RESPONSE TO SUBMISSION

LANDSCAPE
MELROSE PARK SOUTH

OPEN SPACES
MELROSE PARK SOUTH

OPEN SPACES - WEST SITE
MELROSE PARK SOUTH

Melrose Park South - West
OS4

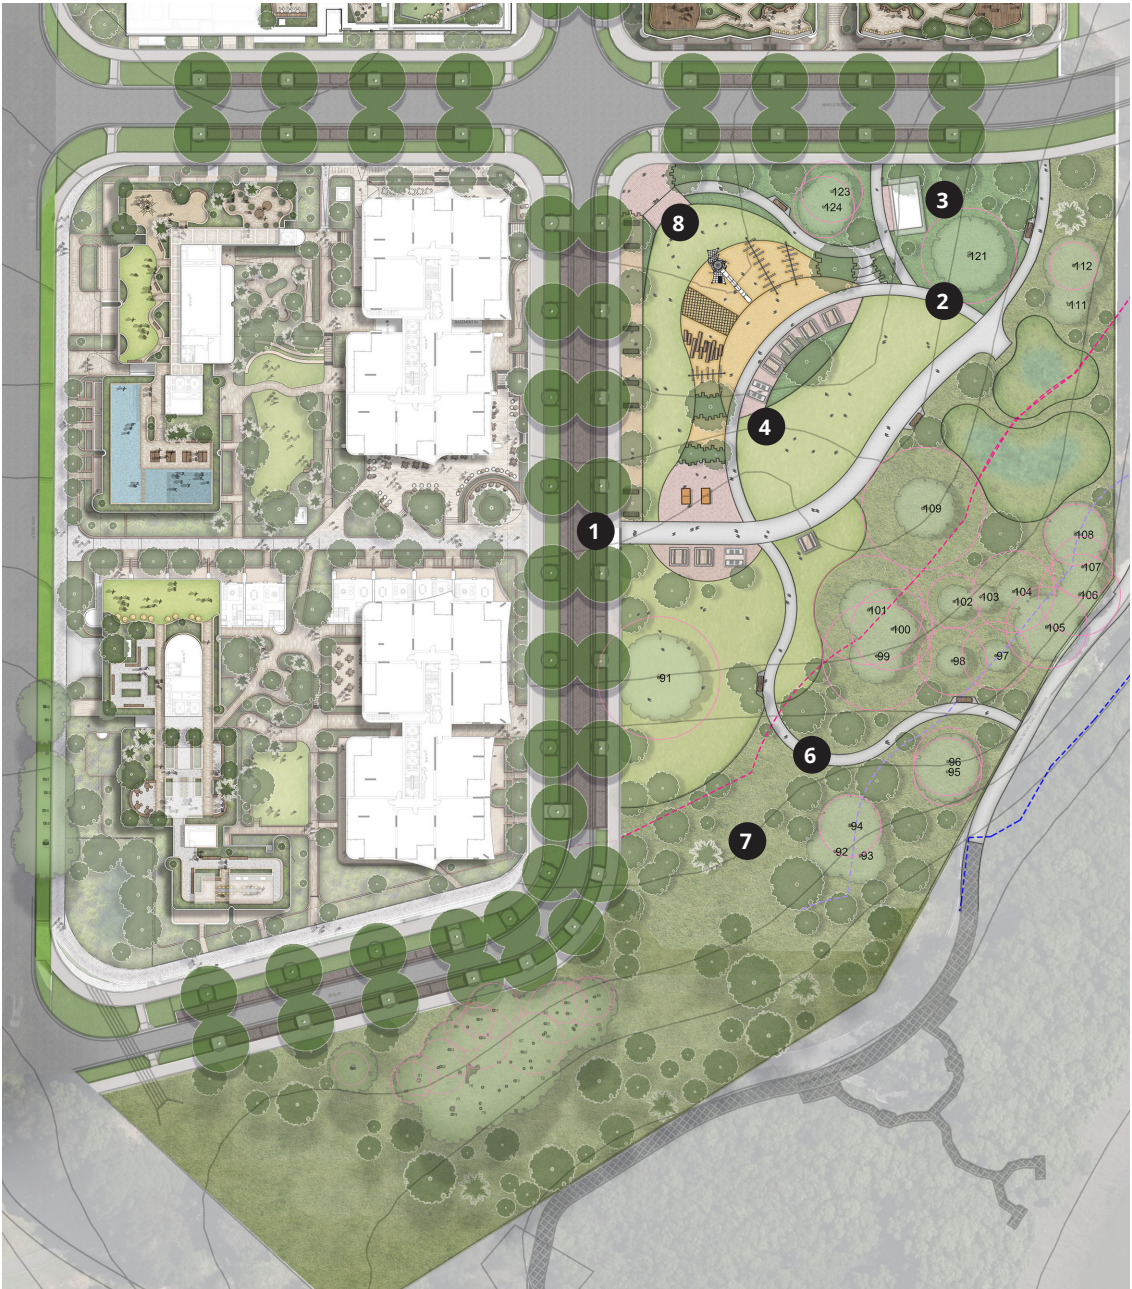
- + All pathways should align with the street network and pedestrian linkages from adjacent communal open space to provide visual connections that minimise wayfinding signage requirements (i.e. northern entry to Hughes Avenue and western boardwalk to Block 3 communal open space).

- + Council also requests that the proponent provide paved connections between park corner entry and playground Softfall zone for accessibility.
- + The BBQ area should be consolidated and relocated away from amenities building and include shelter(s) over the BBQ area (see figure below).

April 2025 - SSDA Plan

January 2026 - RTS Plan

Existing Trees to be Retained

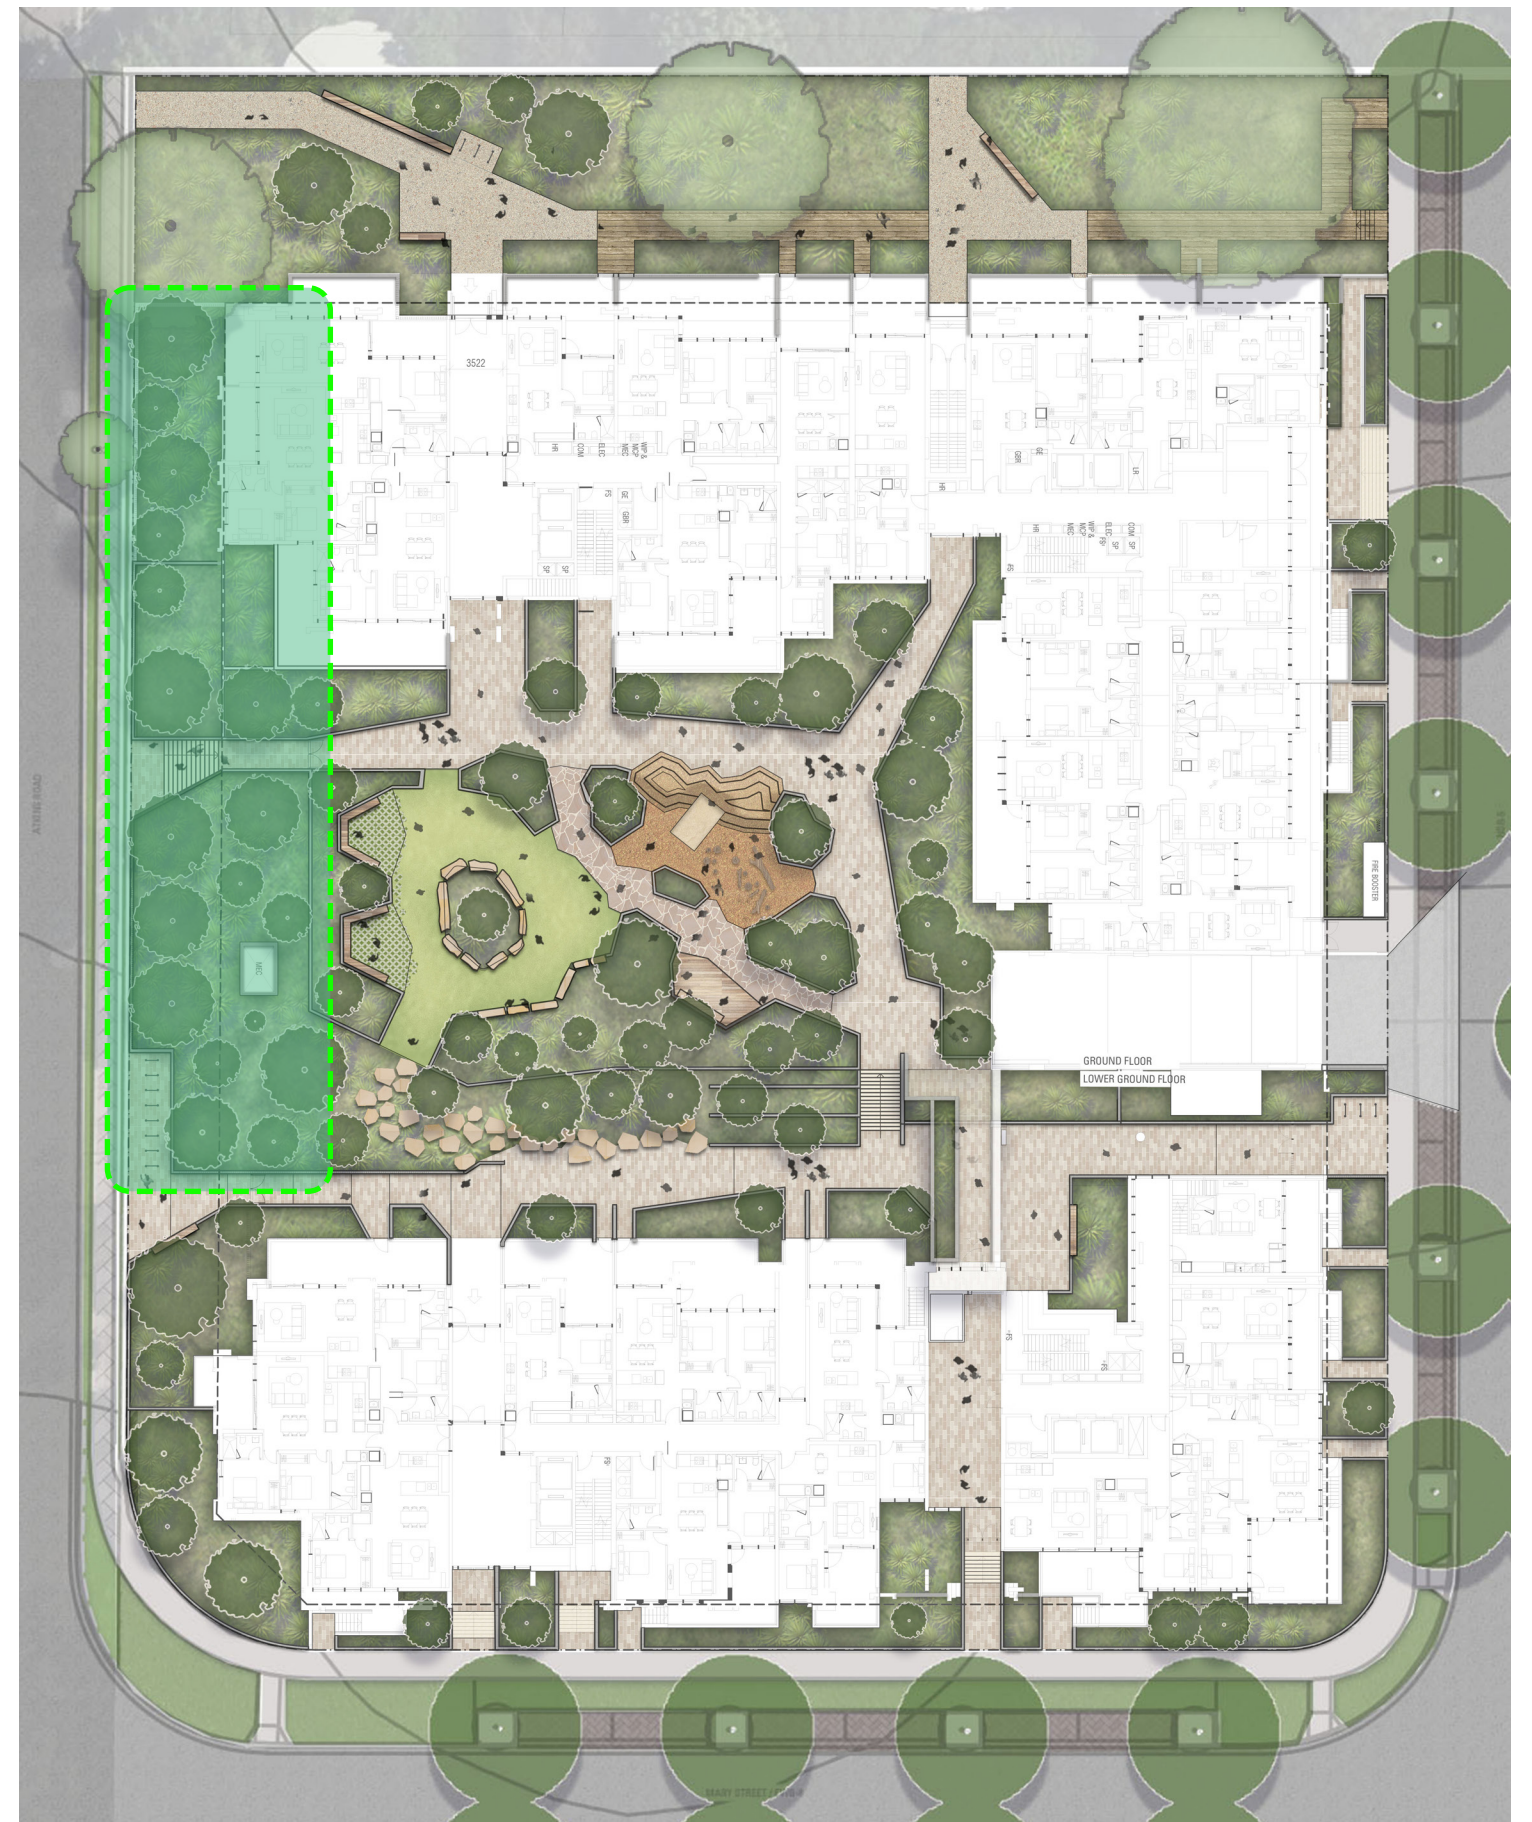
- + The design has been shown with a 15m setback to the north to enable retention of existing trees 24, 25, 26, 29. An elevated walkway is shown through the TPZ of these trees which is supported by Council. However, further details are required on the elevated boardwalk. The design has also tried to retain trees to the western setback 30, 33, 34, 35, 36 by showing the existing levels and treatment to be the same as existing conditions
- + However, services are shown through trees 30, 33, 34, 35, and 36. In addition, additional fill is shown over the trees 33, 34, 35, 36 in section A.

- + Council supports the removal of trees 30, 33, 34, 35, 36 due to the major encroachment within the TPZ's from the services, level changes and building alignment. Replacement trees are to be shown. Note this has not been discussed in the AIA.

Melrose Park South - West B1

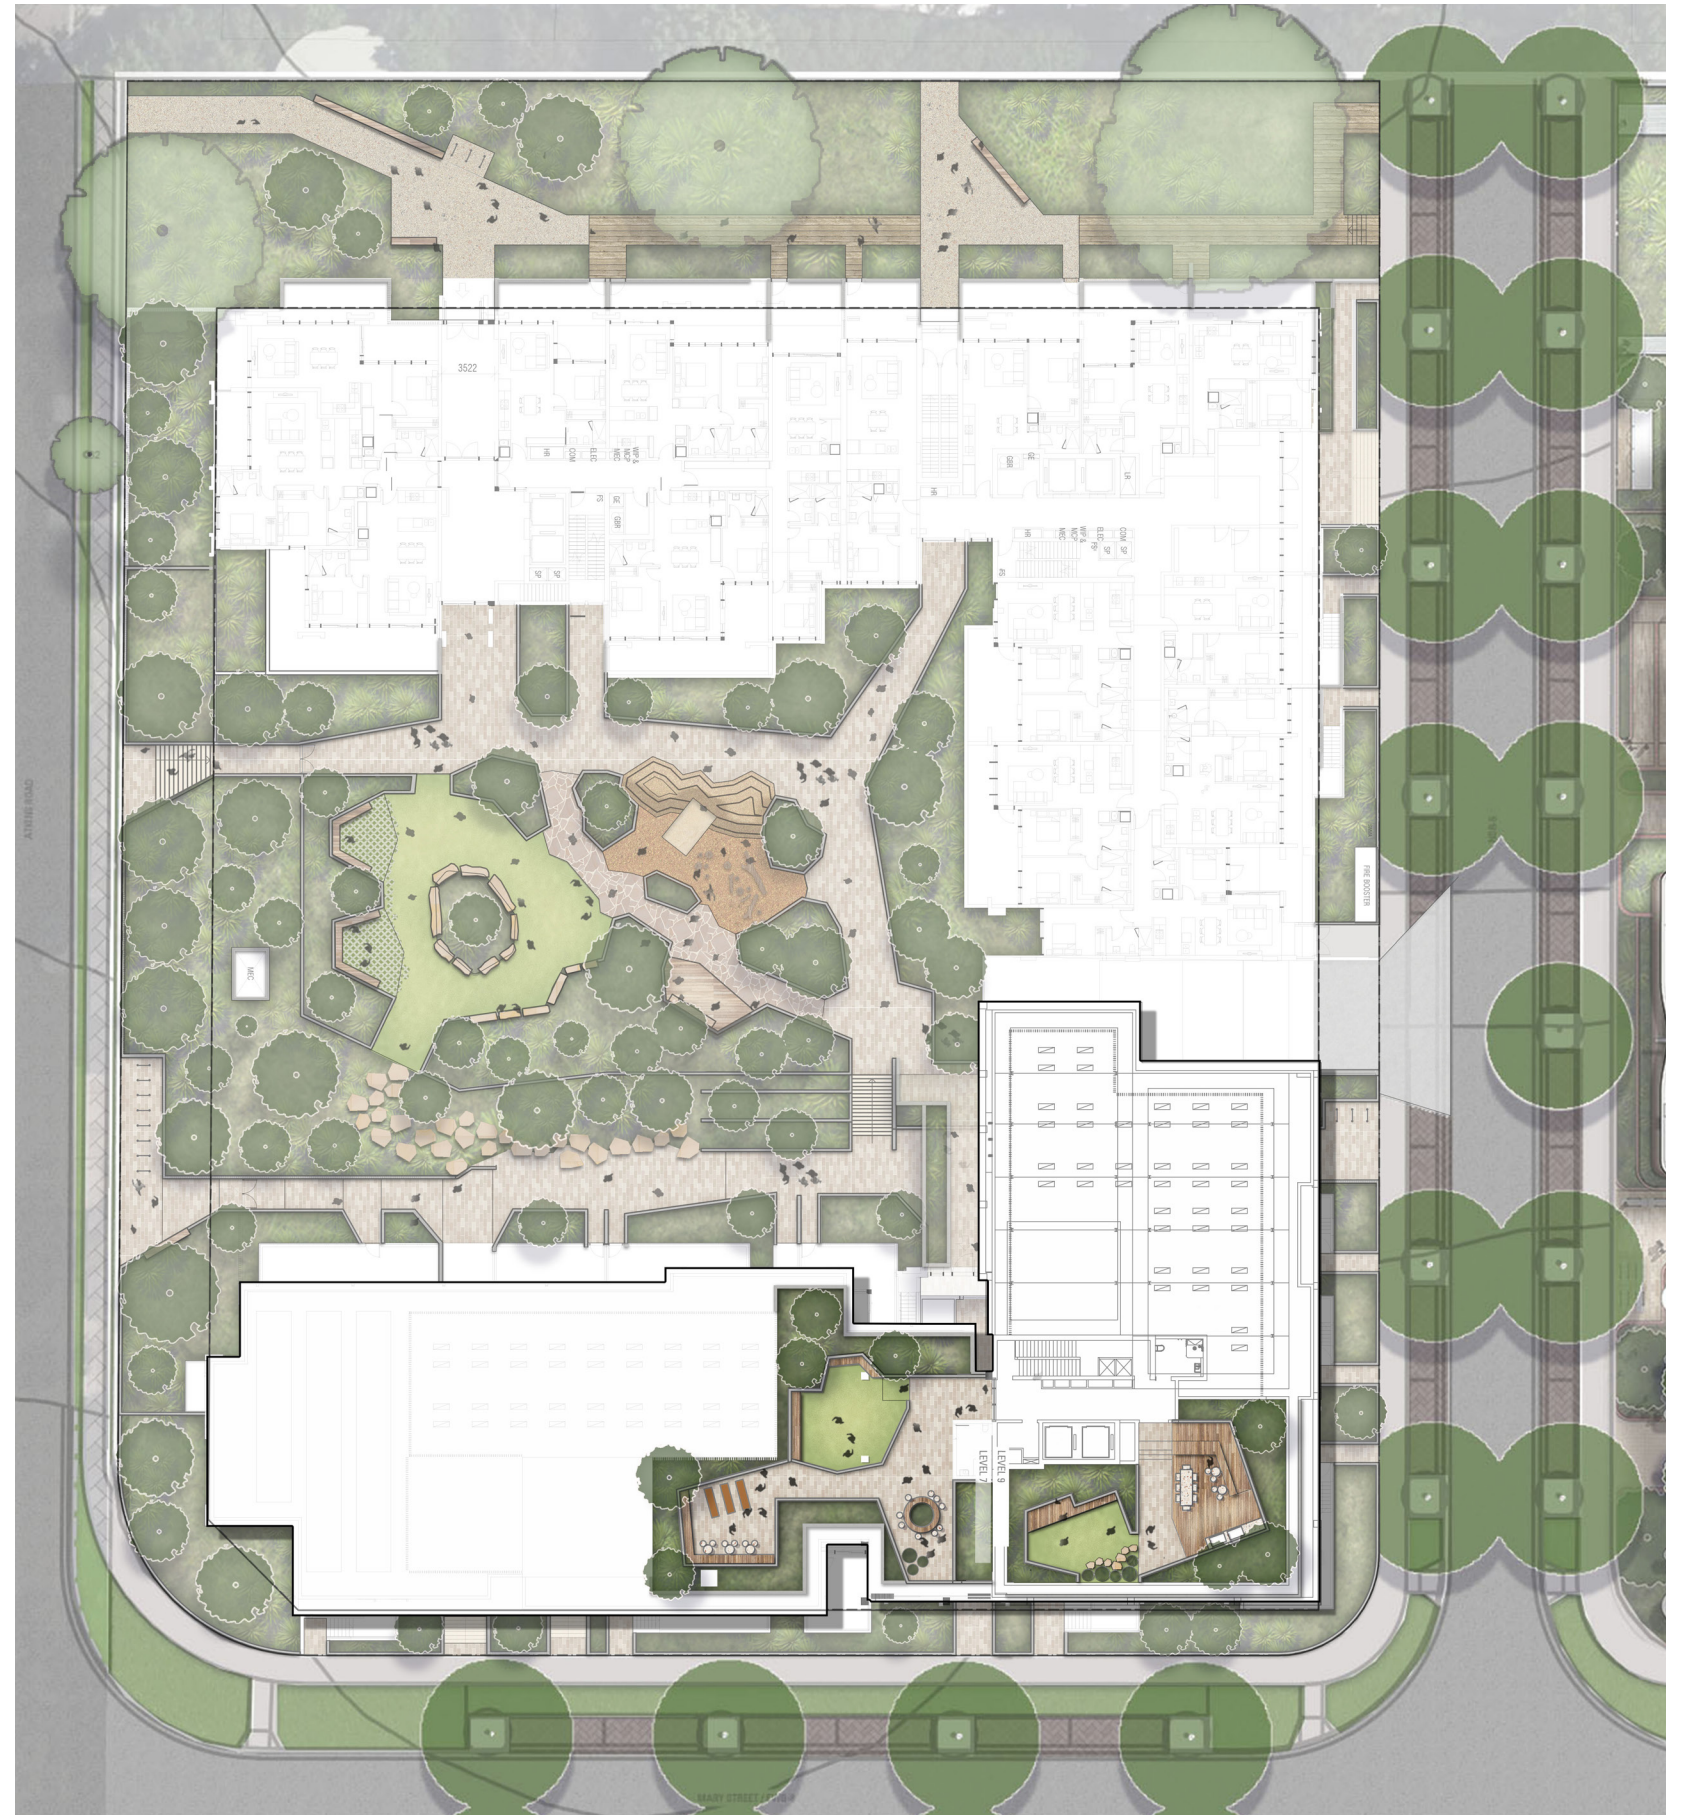
The communal open space design on the ground floor is supported and meets the design objectives and guidelines as described in Part 3D of the Apartment Design Guide (ADG). However, the design of the landscaped areas are not coordinated with the architectural plans, civil plans and arborist input. There are several areas of concern that are not currently supported by Council. The following points are recommended to be addressed in the amended plans:

- + A medium tree Brachychiton acerifolius (Ba) (Height 12m+) is shown as a feature tree in a tiny pot (max. 1.5m3) which is below the 35m3 soil volume required under the ADG 4P. This must be revised of the tree deleted.

- + There are a series of stepping stones through a planted area to a meditation garden. However, the proposed trees are too small to walk under (Corymbia 'Summer Beauty' - 5m) and therefore does not work. A larger tree species is to be planted here if the intention is to be able to walk below the tree canopy cover.

- + Bridge walkway planting reflected in landscape plan,
- + Any soil mounding does not exceed 1 in 8.
- + Soil volume across Block B1 has been reviewed and suitable tree species proposed to meet ADG's soil on structure minimum requirements. Revised tree canopy and soil depth calculations provided in appendix.

- + Proposed turf areas over structure is consistent with the minimum soil depth requirements noted in the ADG.
- + Tree symbols reviewed and amended (where necessary) to convey correct canopy size.

- + Planting areas reviewed and updated accordingly to reflect RTS scheme.
- + Existing tree locations shown as per the survey provided to Arcadia and numbered as per the AIA report.

- + Meditation garden redesigned and tree planting revised in this location.

Soil Depth Plan

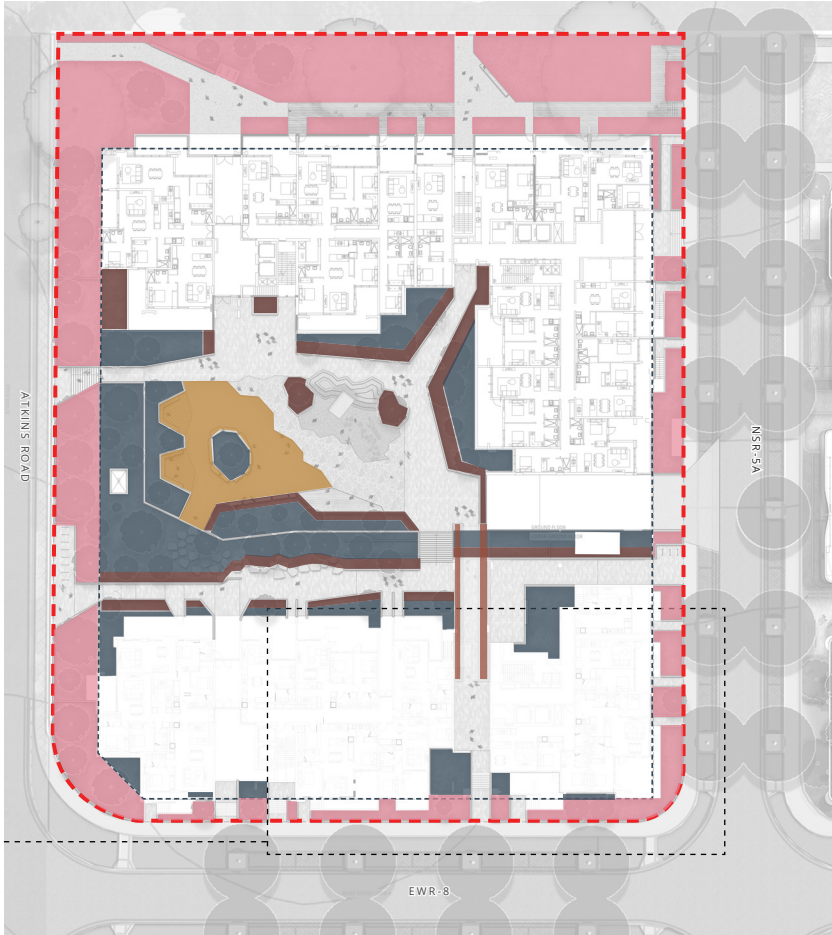
The deep soil zone should be separated from the planting on structure soil depths.

The ground and rooftop terraces have also been amalgamated on one plan. For legibility plan should be split into the different landscape levels.

The m3 calculations should also be added to ensure there is sufficient soil volume available for the proposed trees within each planter to meet the ADG 4P planting on structure requirements.

Soil depth plans include the following amendments:

- + Deep soil zones separated from 1m soil depth areas
- + Separated soil depth plans for different building levels
- + Soil volume metrics included in addition to soil depth.

Refer to updated soil depth plan adjacent and in appendix.

Coordination with Stormwater Plan, WSUD, bulk earthworks

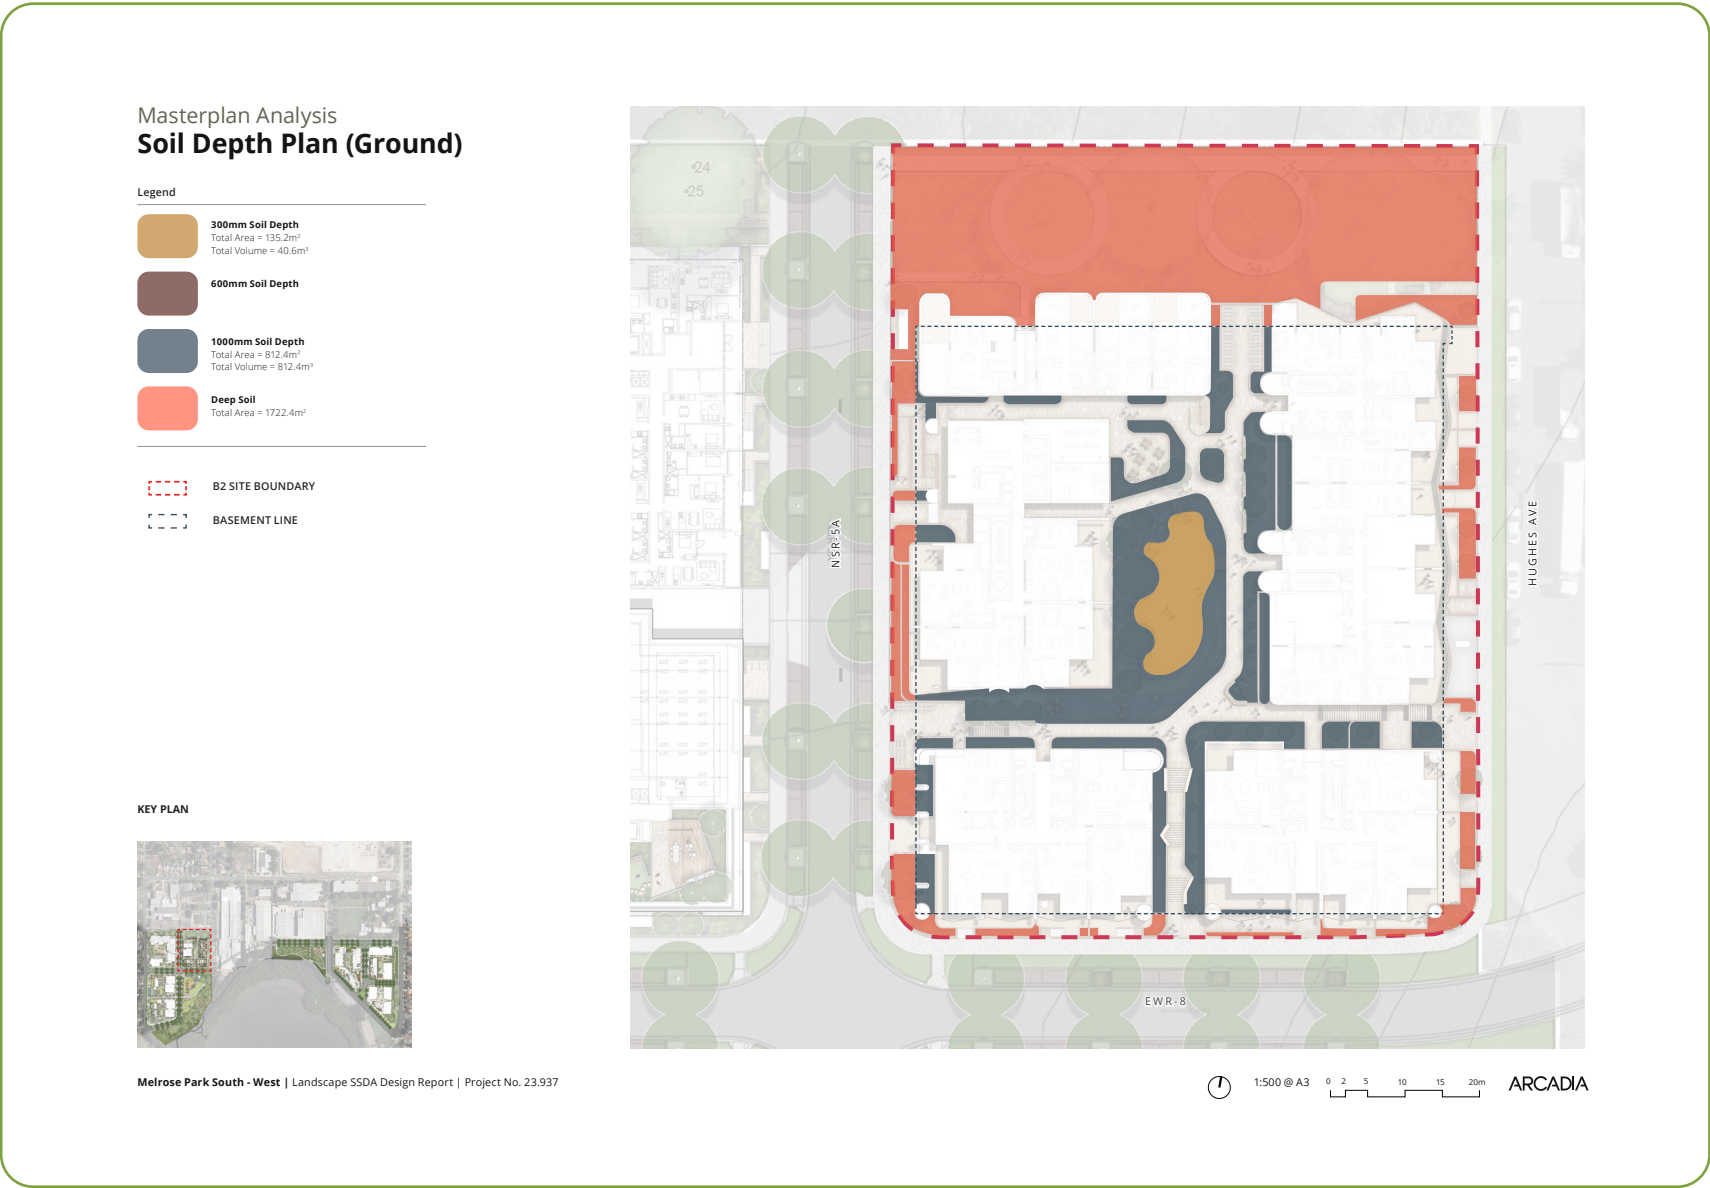
- + Landscape, arborist and civil are not coordinated. The civil plans are showing a rainwater tank and fire tank within the northern setback outside the basement alignment. This has not been shown or considered in the landscape plans.
- + The landscape plans are not showing any stormwater pits. This must be shown to ensure the tree locations and landscape design is coordinated with the civil requirements.
- + The arborist report should discuss the impacts of the underground services in the report.

Planters on structure meets ADG’s soil volume requirements. Soil depth plans include the following amendments:
